**Project: Pier A Structural Repairs Project – Phase II  
General Contractor Services –  
Request for Proposals (“RFP”)**

**Date: August 15, 2023**

**Addendum #4  
# of Pages: 112**

**PIER PART PLAN A**  
N.T.S.

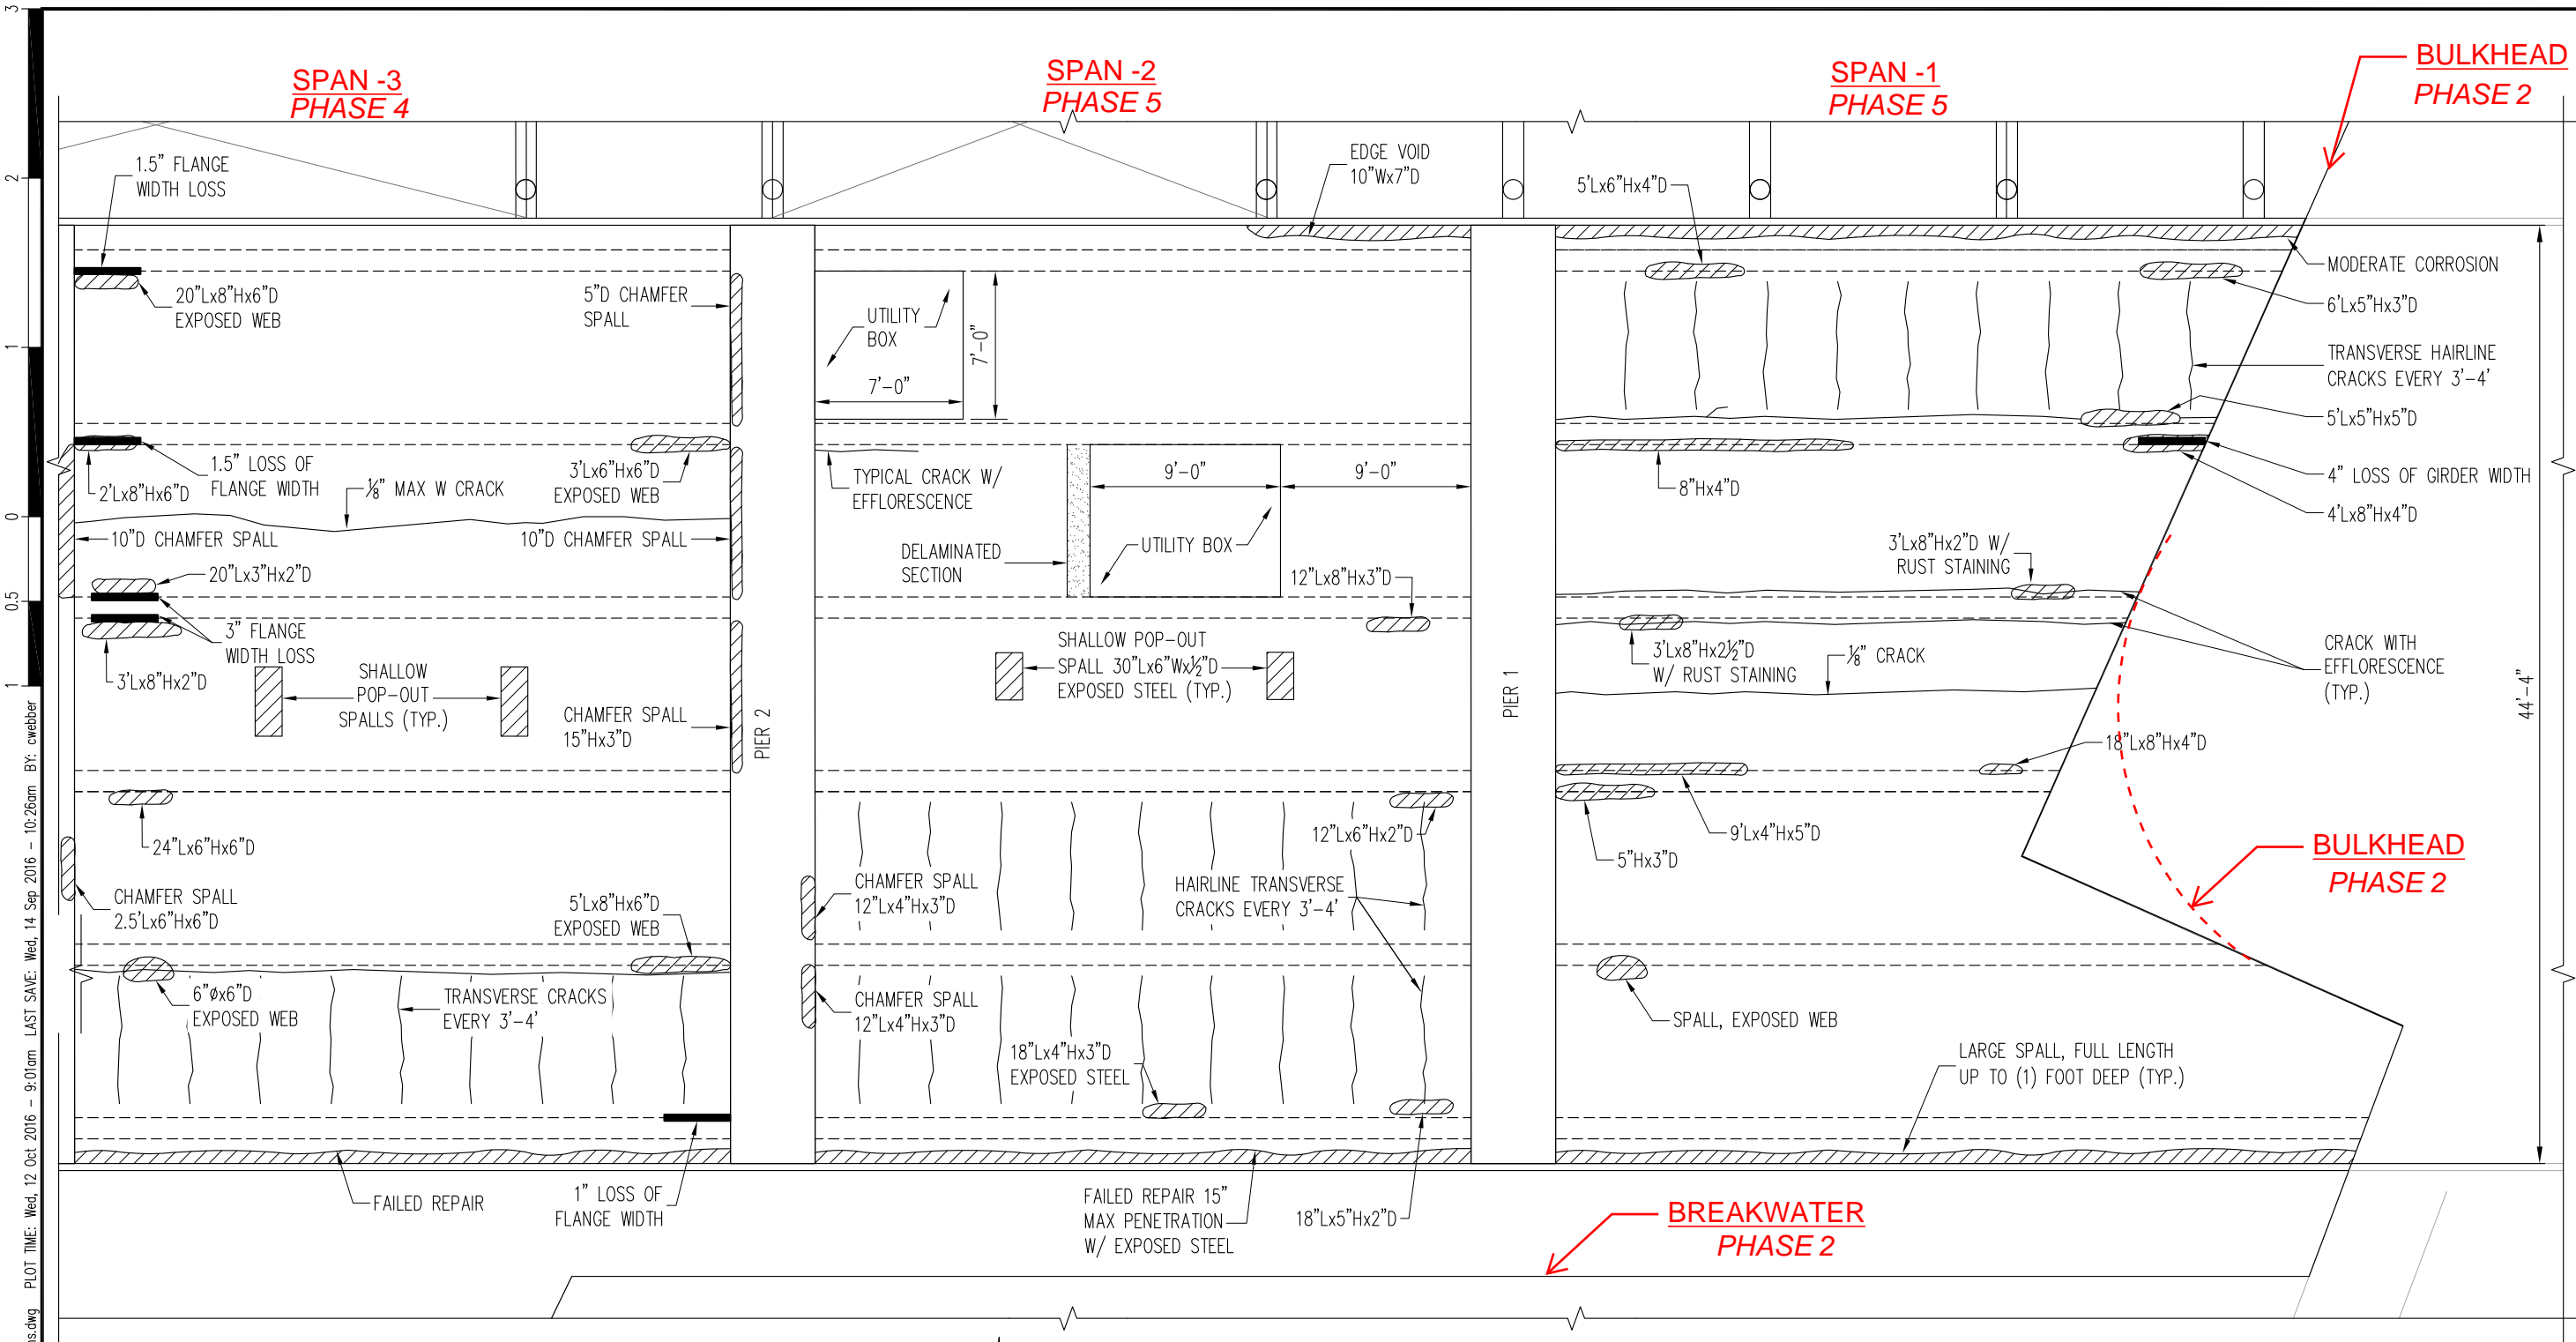
15. Please clarify the Iron Girder Repair details on sheet S-9 correspond to bid Item 11 Girder Flange Repair. If so, please identify where on sheets S-4 through S-7 they are located and what the dimensions are.

***See the Legend item "Knife Edging of Girders" in Drawings S-4, S-5, S-6, and S-7.***
